22/02771/OUT – LAND NORTH OF CAMBRIDGE NORTH STATION, MILTON AVENUE, CAMBRIDGE STATEMENT IN RESPONSE TO COMMENTS OF CAMBRIDGESHIRE COUNTY COUNCIL IN ITS ROLE AS THE MINERALS AND WASTE AUTHORITY (MWPA).

This Statement provides a response to the comments of Cambridgeshire County Council in its role as the Minerals and Waste Authority (MWPA) to application 22/02771/OUT.

The comments of the MWPA were provided on 28 July 2022 with an objection to the proposal requesting further information demonstrating the compatibility of the development with the safeguarded aggregates railhead (TIA), and the Cowley Road Waste Management Area (WMA).

630_01 (MP) 021 WILD PARK AND AGGREGATES YARD INTERFACE P1

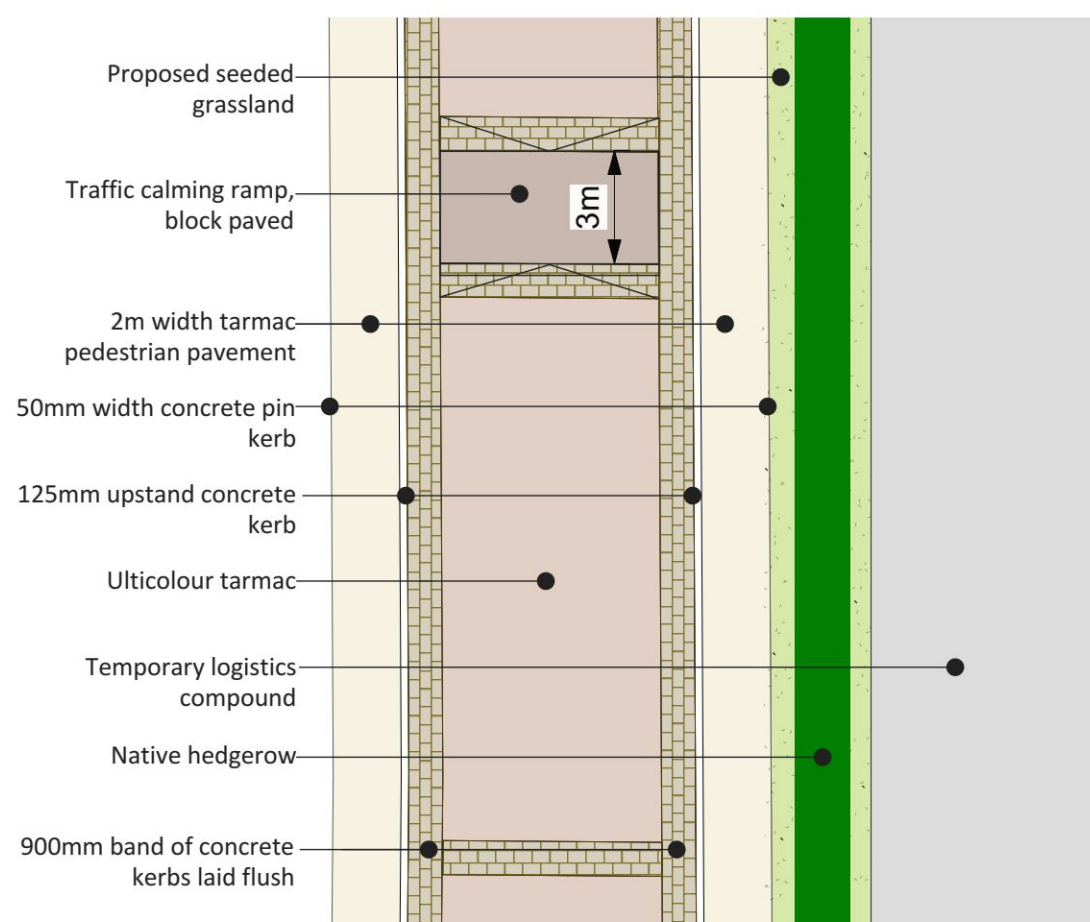
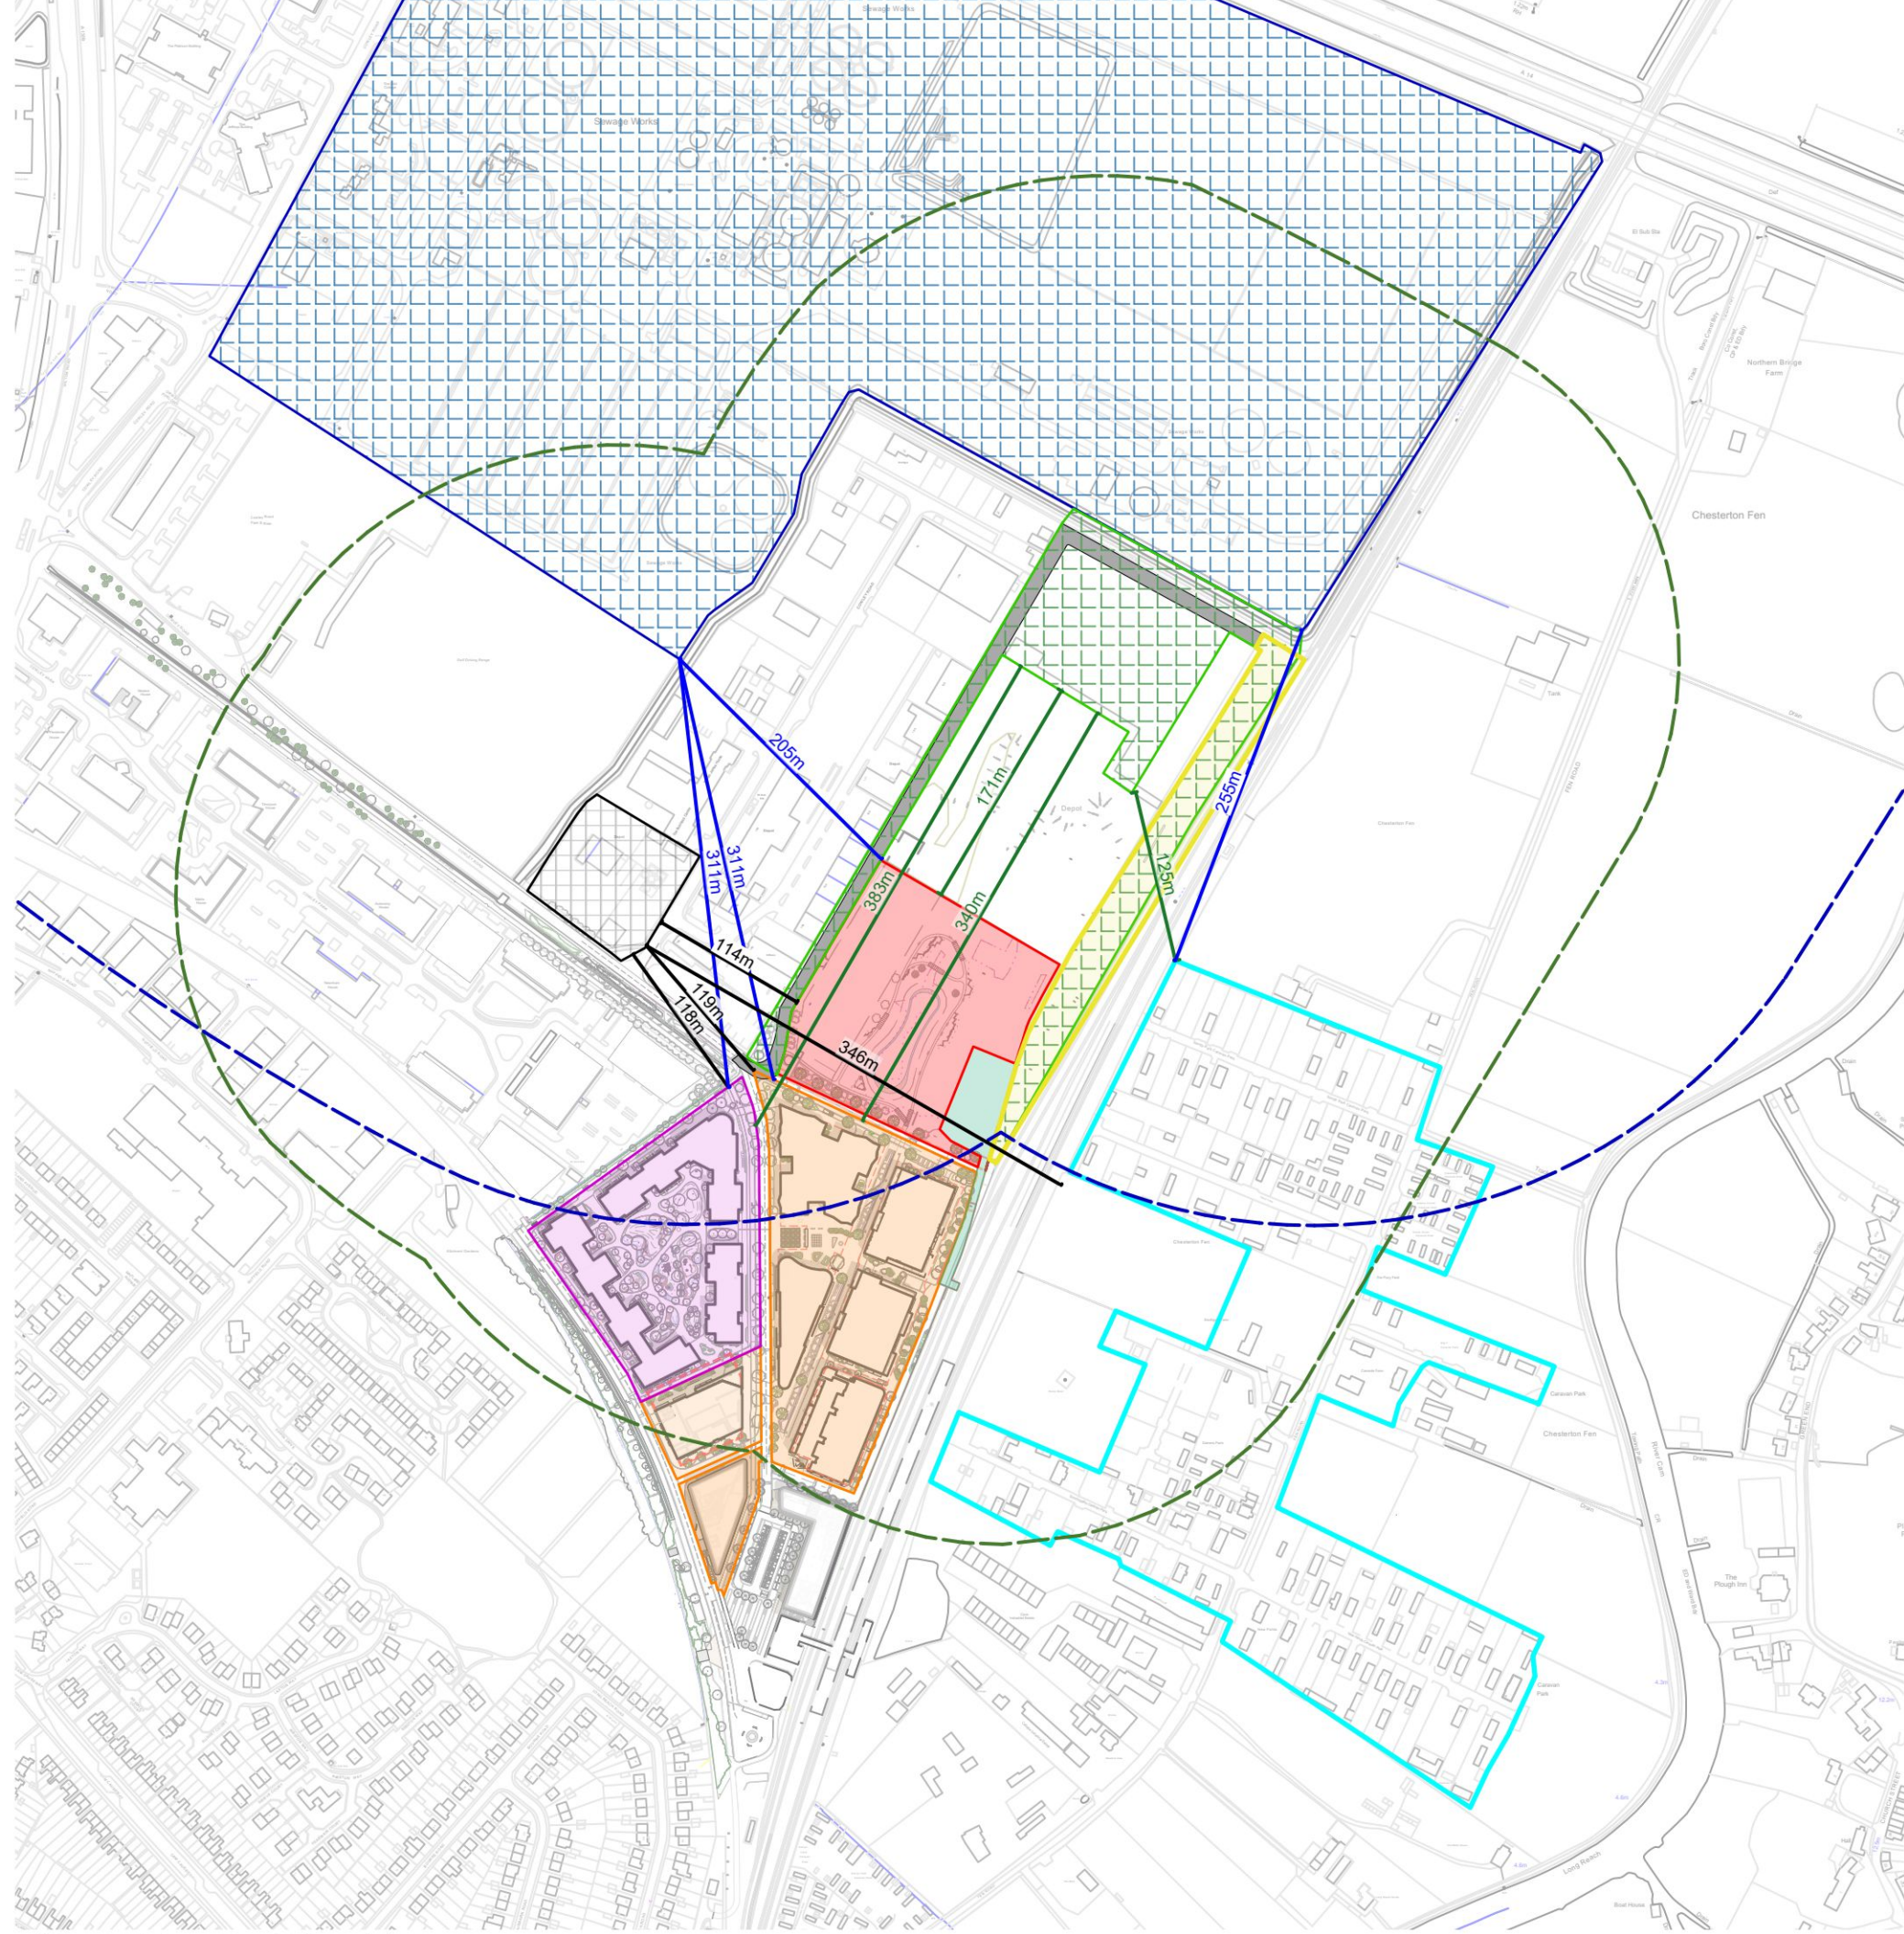
2. *A description and/or plan showing the different uses within the proposed development, the distances between those proposed uses and the safeguarded sites. This should also detail if there are any barriers between the proposed uses and the safeguarded sites.*

2. A description and/or plan showing the different uses within the proposed development, the distances between those proposed uses and the safeguarded sites. This should also detail if there are any barriers between the proposed uses and the safeguarded sites.

Please see the Wild Park and Aggregates Yard Interface plan (ref: 630_01(MP)021), which has been prepared to demonstrate the relationship between the proposed development and the safeguarded sites. This plan also details the proposed haul road linkage between the proposed development and the safeguarded sites, to maintain access to these elements as part of the proposed development.

Figure 1 Map Showing Nearby Sensitive Receptors and Industrial Sources

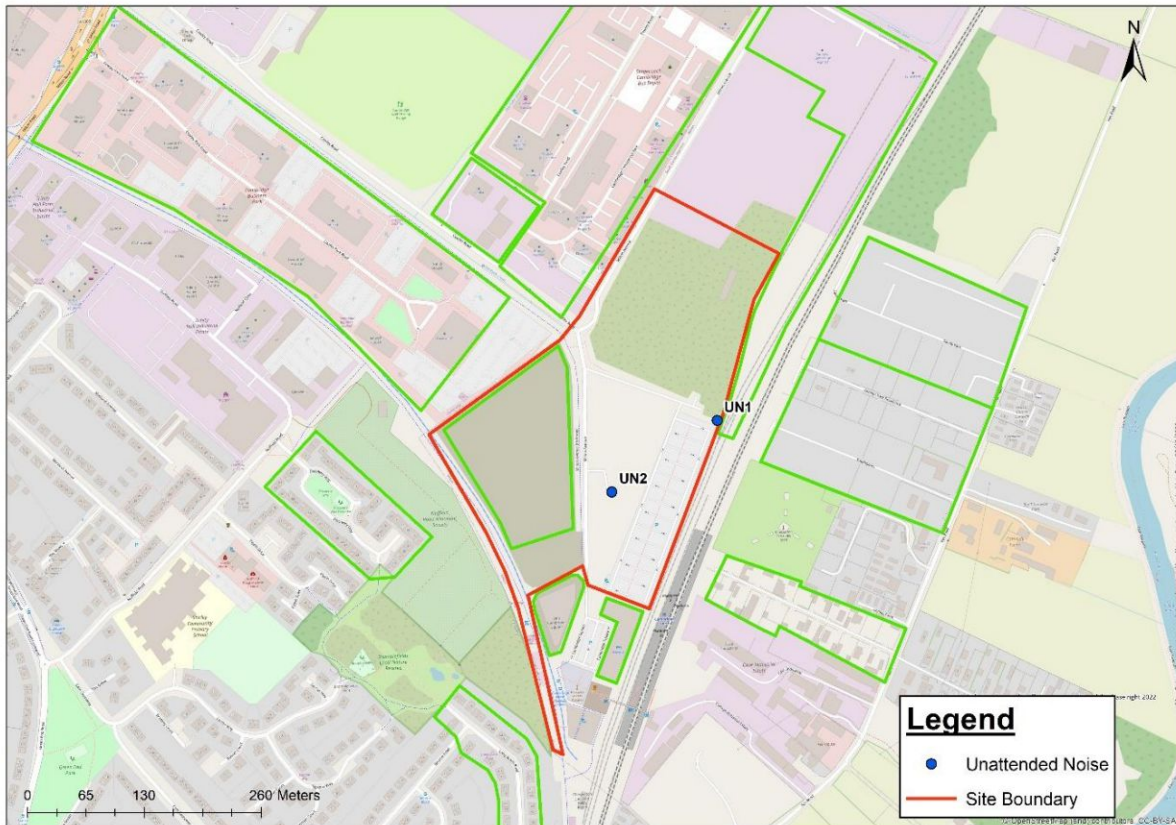
- 1.1.4 Due to the proximity of both the AR and the WTS to the Proposed Development, there is concern that the future users of the Site could be at risk of noise and vibration impacts from these sites, which could give rise to complaints, which could then lead to further constraints on the operation of these facilities. This assessment provides further detail on noise incident on the Site when these sites operate, in support of discharging of the above objections placed on the Proposed Development.

- 3.1.3 The existing and future receptors and type of receptor as well as the sites of industrial noise are presented in **Table 1**; their locations are shown in **Figure 1**.
